INVITATION TO BID RESERVE AT HUDSON CROSSING PUBLIC IMPROVEMENTS– ADDENDUM #1
March 1, 2019

Engineering Plans
for
the Village of Oswego

Project No.:	SH0002
File Name:	16_REM_HAR.dgn
Issue Date:	3/1/2019
Scale:	1" = 20'
Sheet Number	16

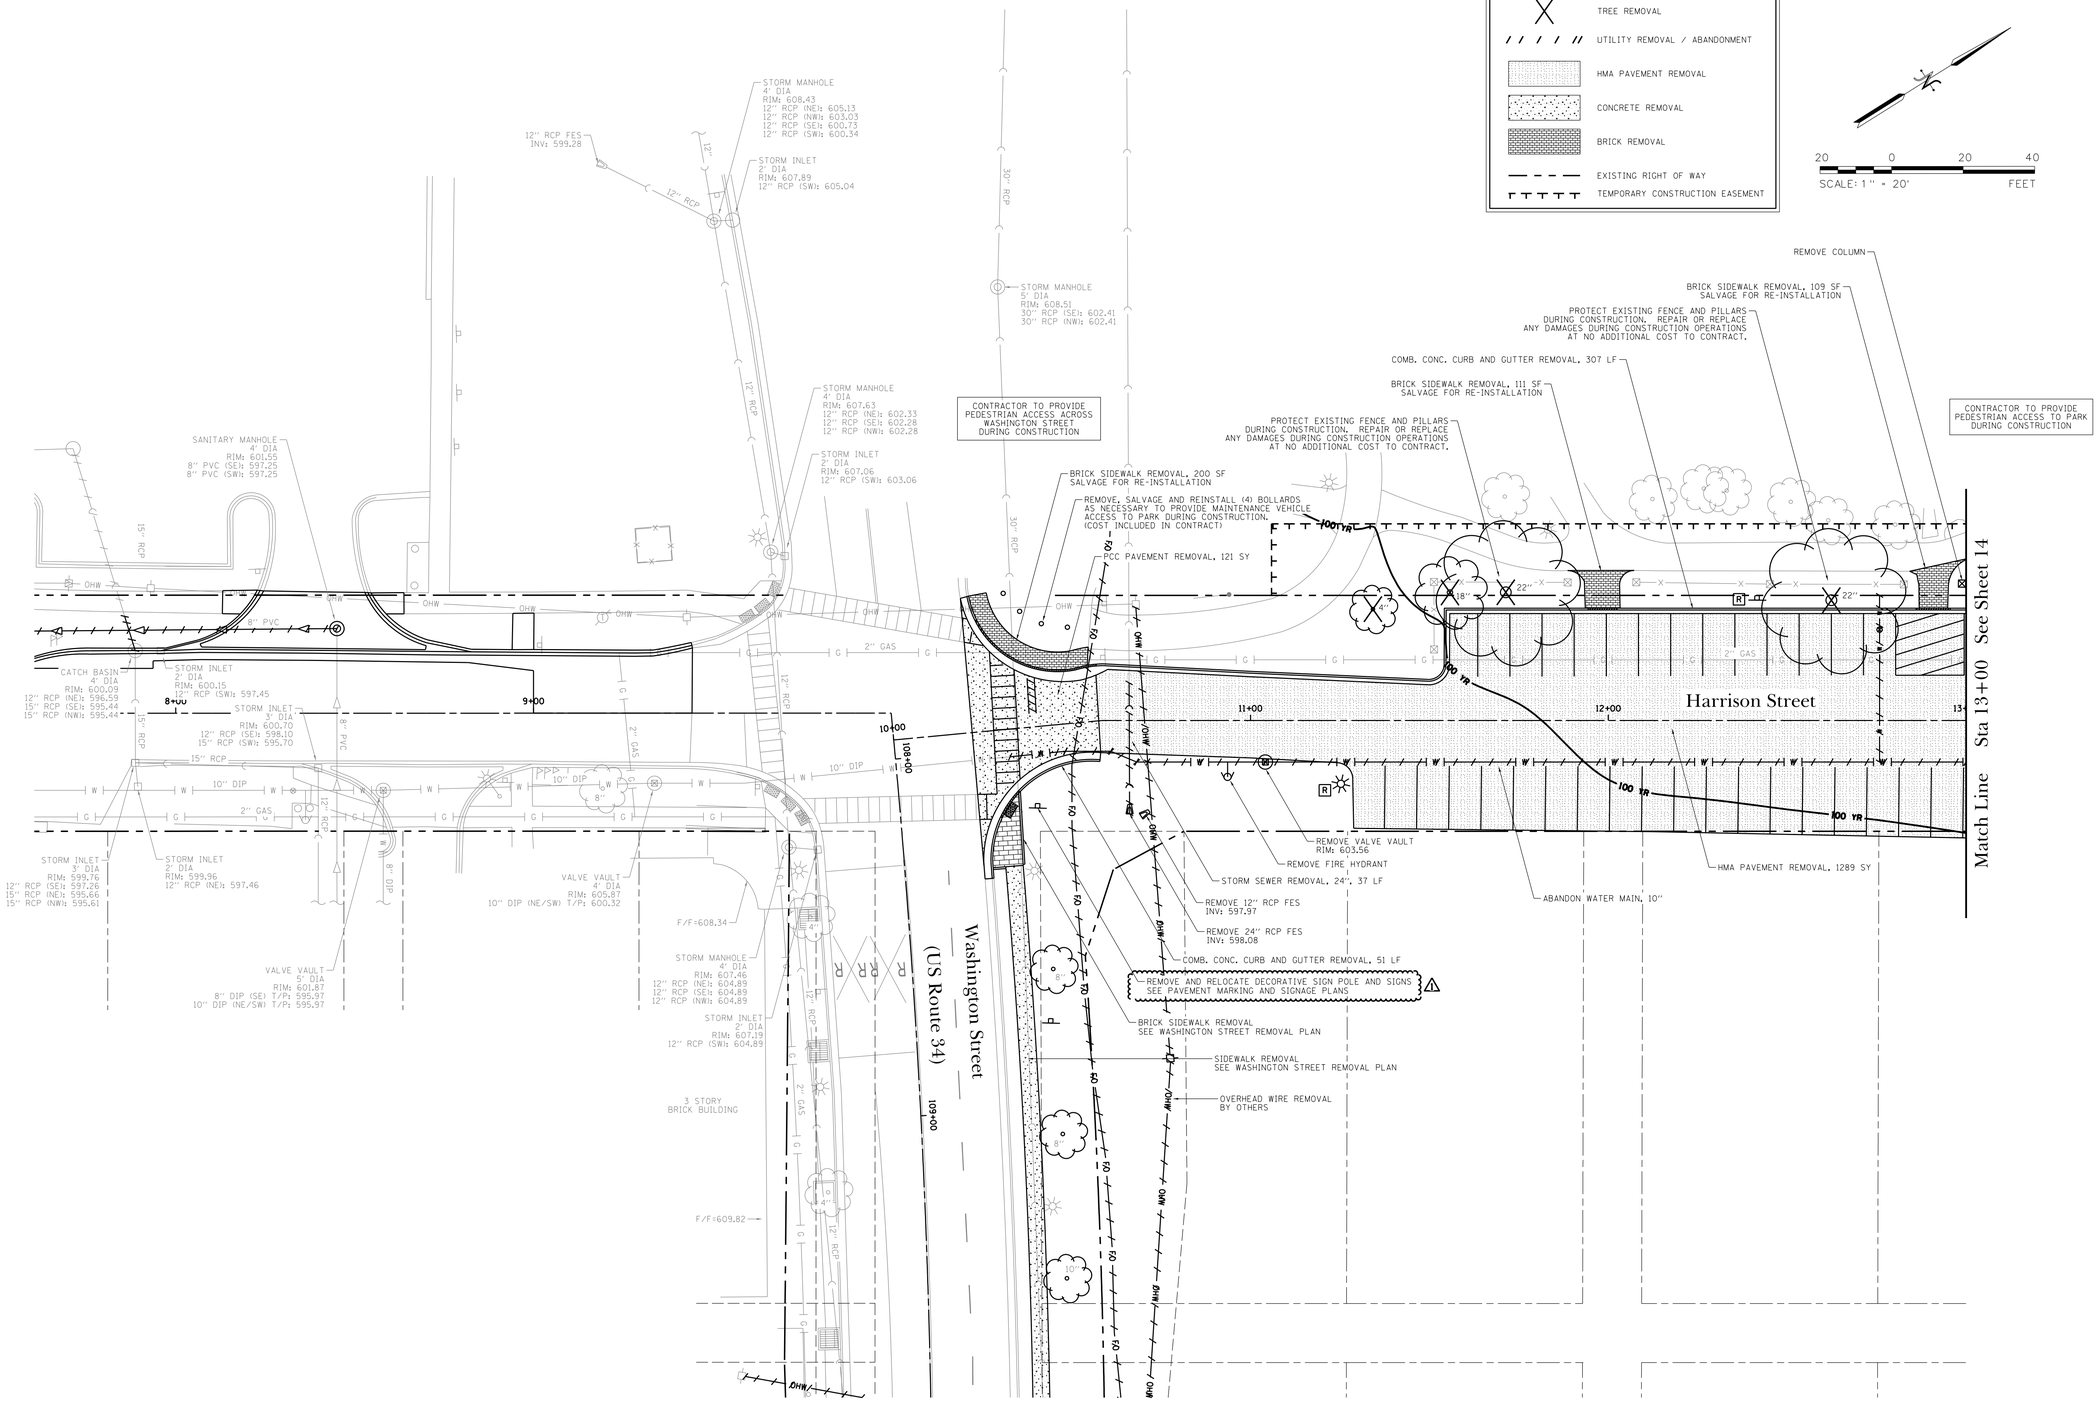
7. Sheet No. 16 – Removal Plan – Harrison Street
   A. Changed callout "Remove and Relocate Decorative Pole and Signs".

Project No.: SH0002
File Name: 18_REM_ADAMS.dgn
Issue Date: 3/1/2019
Scale: 1" = 20'
Sheet Number
18

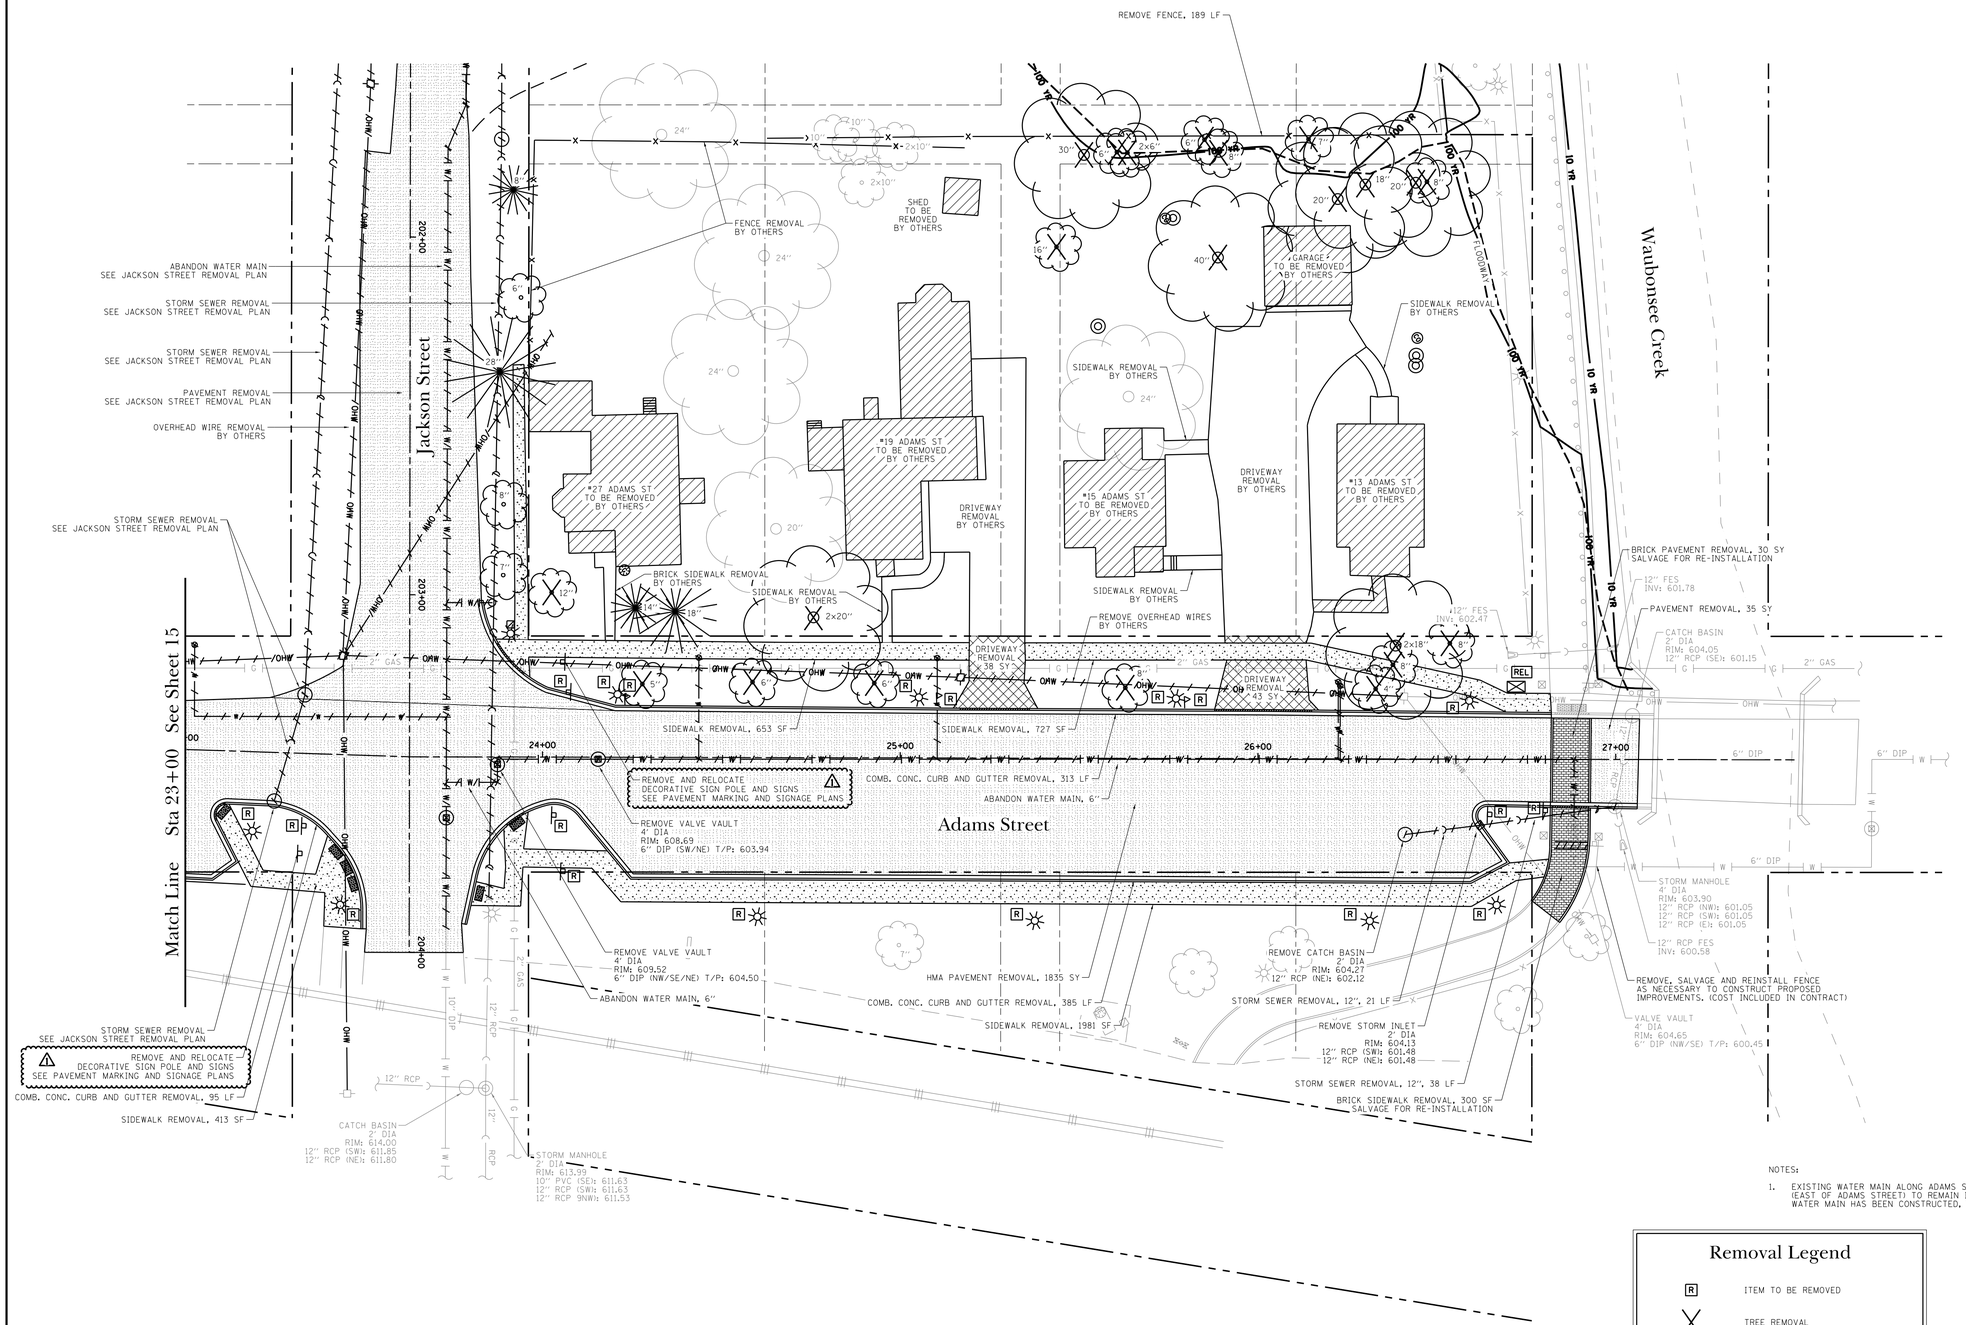
8. Sheet No. 18-19 – Removal Plan – Adams Street

A. Changed callout "Remove and Relocate Decorative Pole and Signs".

Project No.: SH0002
File Name: 22_P&P_HAR.dgn
Issue Date: 3/1/2019
Scale: HORIZ: 1" = 20' VERT: 1" = 5'
Sheet Number
22

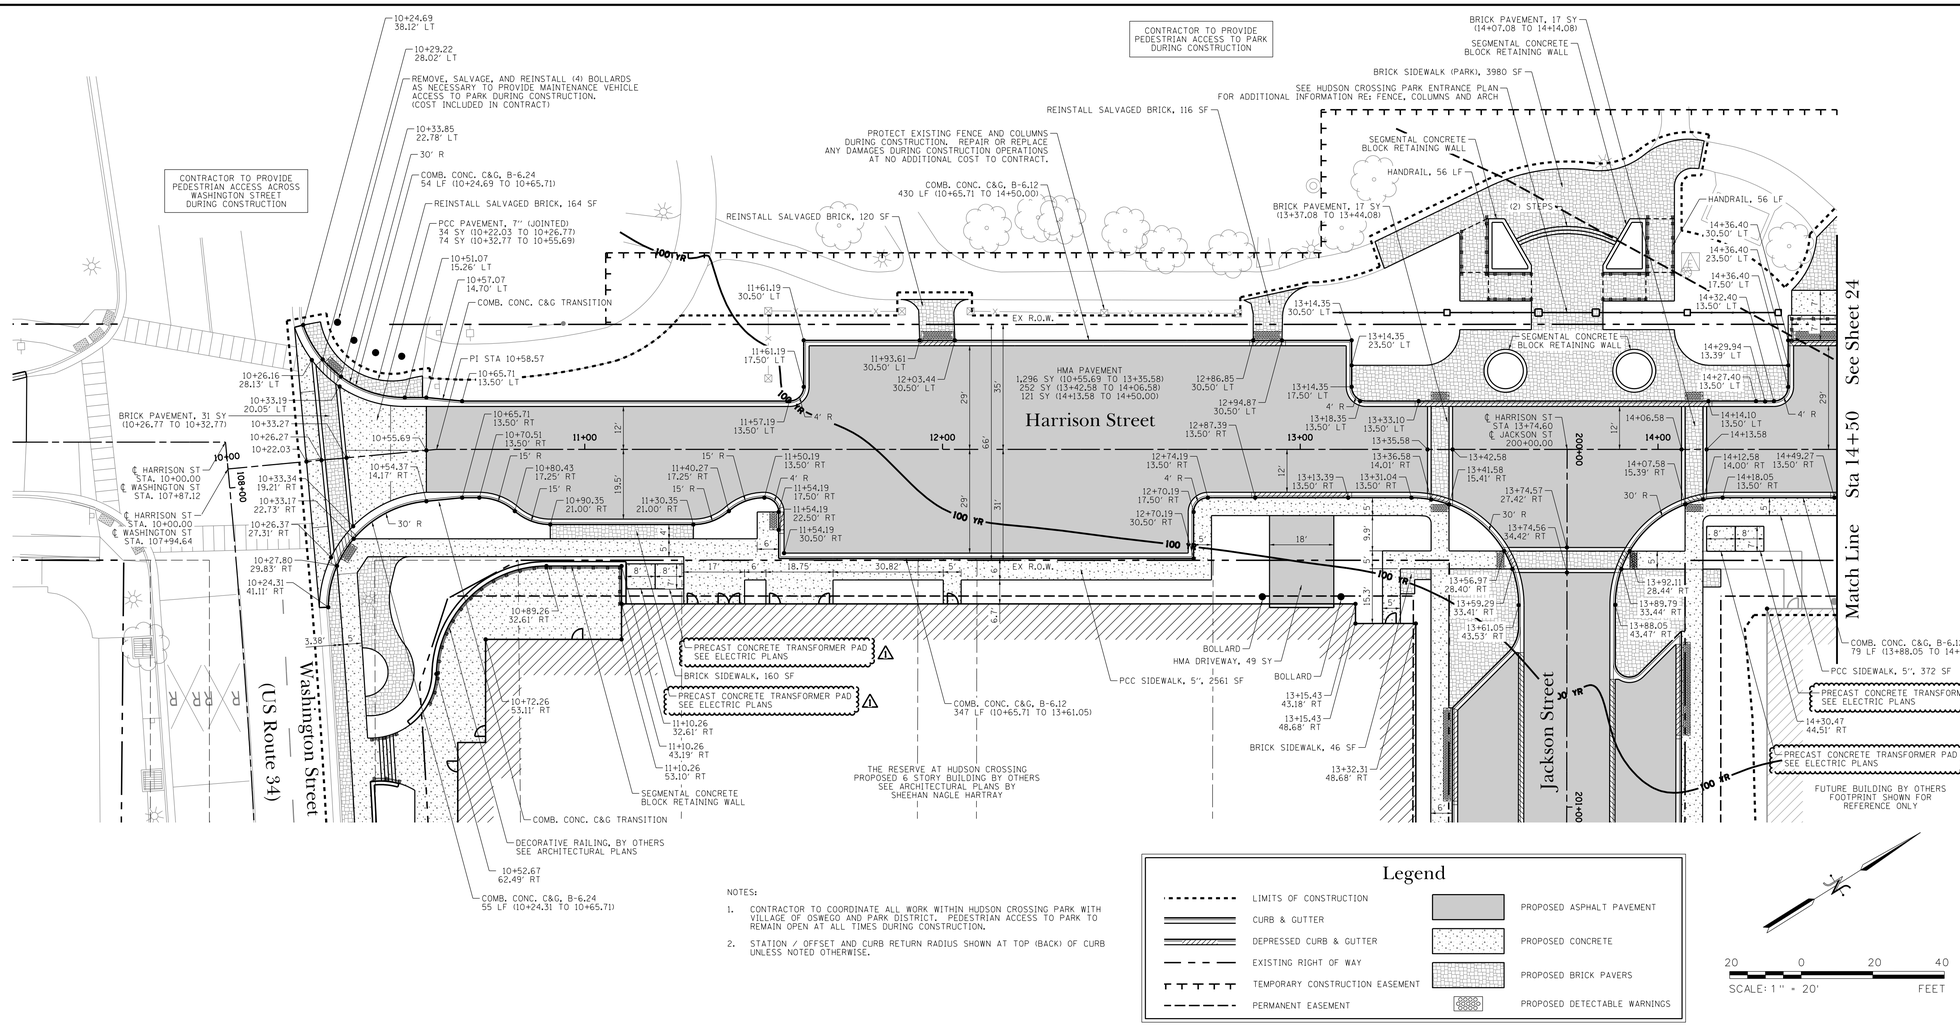
9. Sheet No. 22-28 – Roadway Plan and Profile
   A. Revised approximate bedrock profile.

Project No.:	SH0002
File Name:	46_EROS_HAR.dgn
Issue Date:	3/1/2019
Scale:	1" = 20'
Sheet Number	46

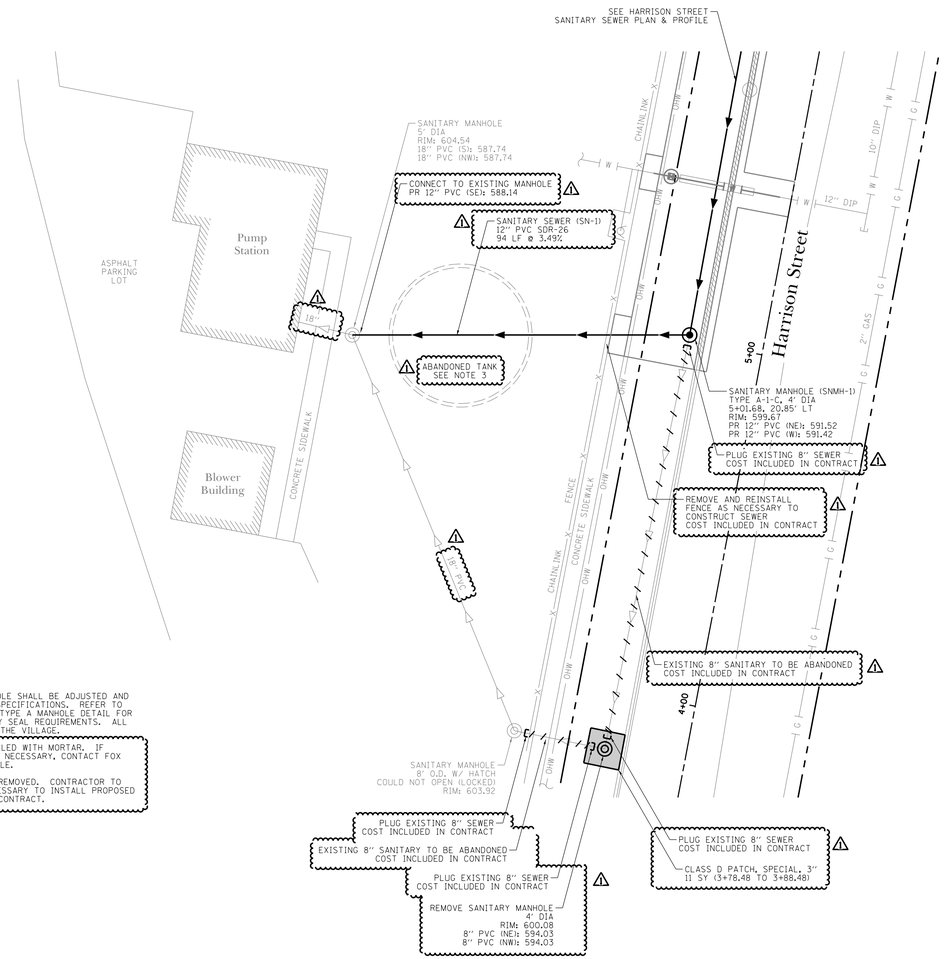
14. Sheet No. 46 – Erosion Control Plan – Harrison Street
    A. 4" Topsoil, Seeding (Cl 1) and Erosion Control Blanket quantity revised from 342 SY to 337 SY per new transformer pads.

Project No.:	SH0002
File Name:	50_SAN_P&P_HAR.dgn
Issue Date:	3/1/2019
Scale:	HORIZ: 1" = 20' VERT: 1" = 5'
Sheet Number	50

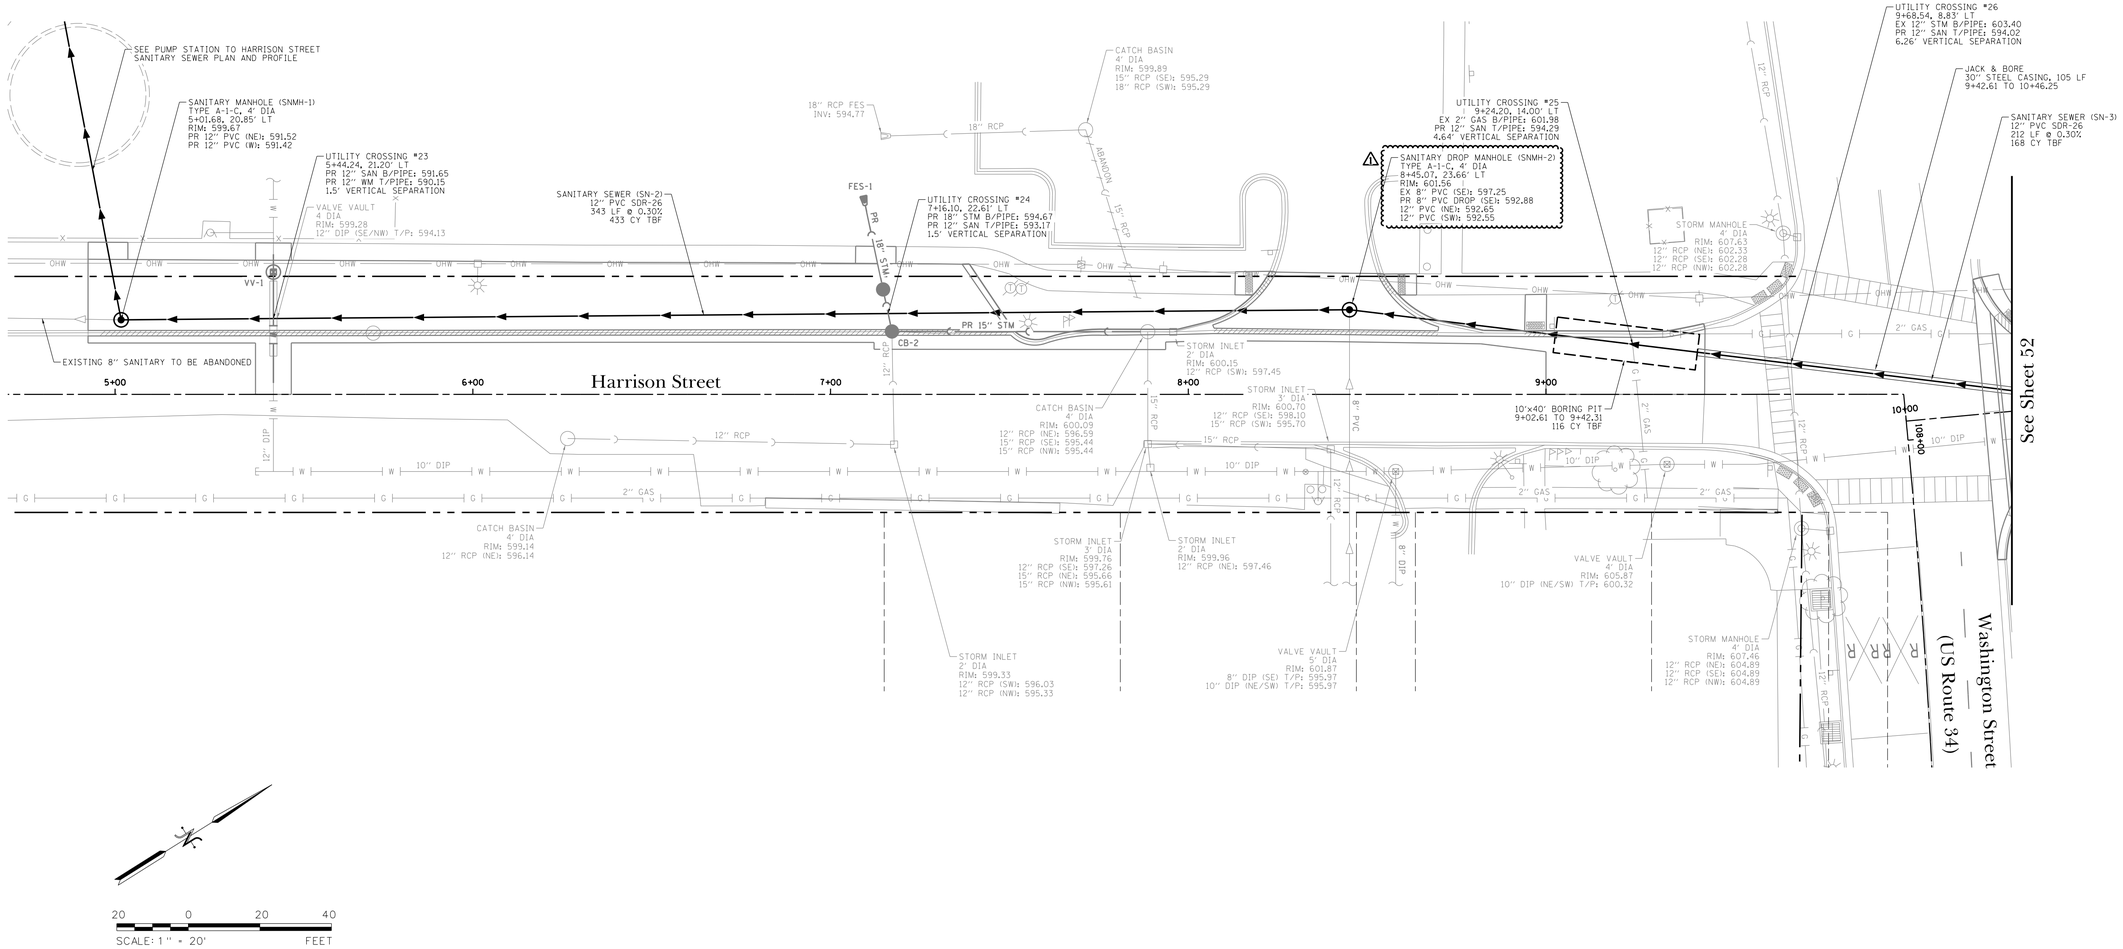
15. Sheet No. 50 – Sanitary Sewer Plan and Profile
    A. Revised approximate bedrock profile.
    B. Added additional information at Pump Station including existing buildings, abandoned tank.

C. Added Note 2 re: abandonment of existing sanitary sewer.
    D. Added Note 3 re: removal of existing tank as necessary for construction of proposed sewer.

E. Revised existing sewer sizes from 24" to 18".
    F. Added Sanitary Manhole to be removed at 3+83.55, 22.62' LT.
    G. Added note to abandon existing sewer between 8' dia manhole and manhole to be removed.

H. Added callouts for plugging of existing sewer to be abandoned.
    I. Added callouts for abandonment of sewer to be included in contract.
    J. Added Class D Patch, Special, 3" at manhole to be removed.

K. Revised proposed 12" sewer invert at connection to existing manhole to elevation 588.14
    L. Revised slope of proposed 12" sewer (SN-1) to 3.49%.
